**Manufactured Home Construction and
Safety Standards; Final Rule**

[Docket No. FR-4886-F-02]

ACTION: Final rule.

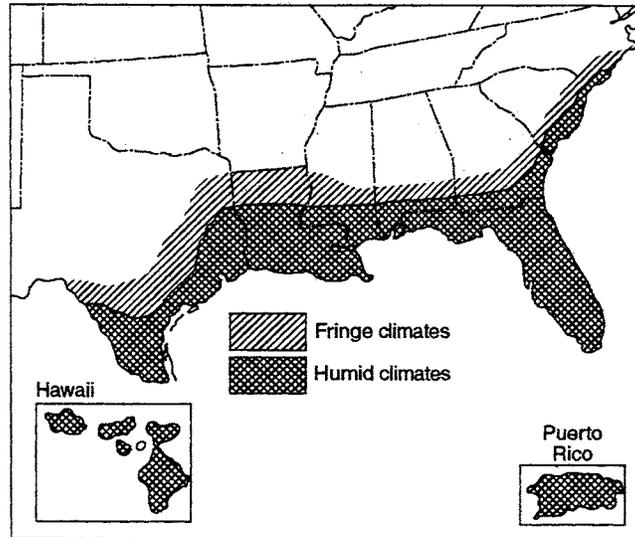
Comment: The proposed condensation control and installation of vapor retarders described in § 3280.504(b)(4) is not practical and should provide exceptions. Several commenters stated that HUD should provide more exemptions, including: (1) Kitchen back-splash materials of less than 50 square feet in the area installed around countertops, sinks, and ranges; (2) bathroom tub areas and shower compartments; (3) cabinetry and built-in furniture, in any location; and (4) hardwood wall paneling used under chair rails in dining room areas, less than 50 square feet in area. One commenter explained that these construction features are commonly installed against exterior walls of manufactured homes and do not represent a large exposed wall where condensation due to the hot-humid climates would appear to be excessive. Also, a September 2000 MHRA study revealed that hardwood paneling is not detrimental to the established proposal waiver requirements of a minimum 5.0 perm rating. Another commenter wrote that it is absolutely necessary to provide some minor exception to the requirement that the interior finish have a combined permeance of not less than 5.0 perms. MHCC has already discussed with HUD the need to include these exceptions, which are part of further changes to the Construction and Safety Standards that have been approved by MHCC. These changes are in concept but have not yet been put into proposed rule form. The vapor retarder location specified in § 3280.504(b)(4) is an alternative to that called for in

Comment: The focus of § 3280.504(b)(4) should be reducing air movement rather than vapor retarders. One commenter wrote that § 3280.504(b)(4) does not address any effective construction measure to reduce the larger problem of air movement into the wall cavity. In fact, the performance measure that would impact the reduction of air movement would be the use of a continuous air barrier. Homes with low permeable sheathings have

Comment: HUD should permit some minor exceptions to the requirements for interior finish materials in hot-humid climates.

HUD Response: HUD agrees with many of the comments; therefore, the final rule in § 3280.504 now includes exceptions to the 5.0 perm requirement for interior finish materials of up to 50 square feet in area.

HUD Response: Section 3280.504(b)(4) of the final rule includes minor exceptions to the 5.0 perm requirement for interior finish materials used in hot-humid climates.

(4) Homes manufactured to be sited in "humid climates" or "fringe climates" as shown on the Humid and Fringe Climate Map in this paragraph are permitted to have a vapor retarder specified in paragraph (b)(1) of this section installed on the exterior side of the wall insulation or be constructed with an external covering and sheathing with a combined permeance of not
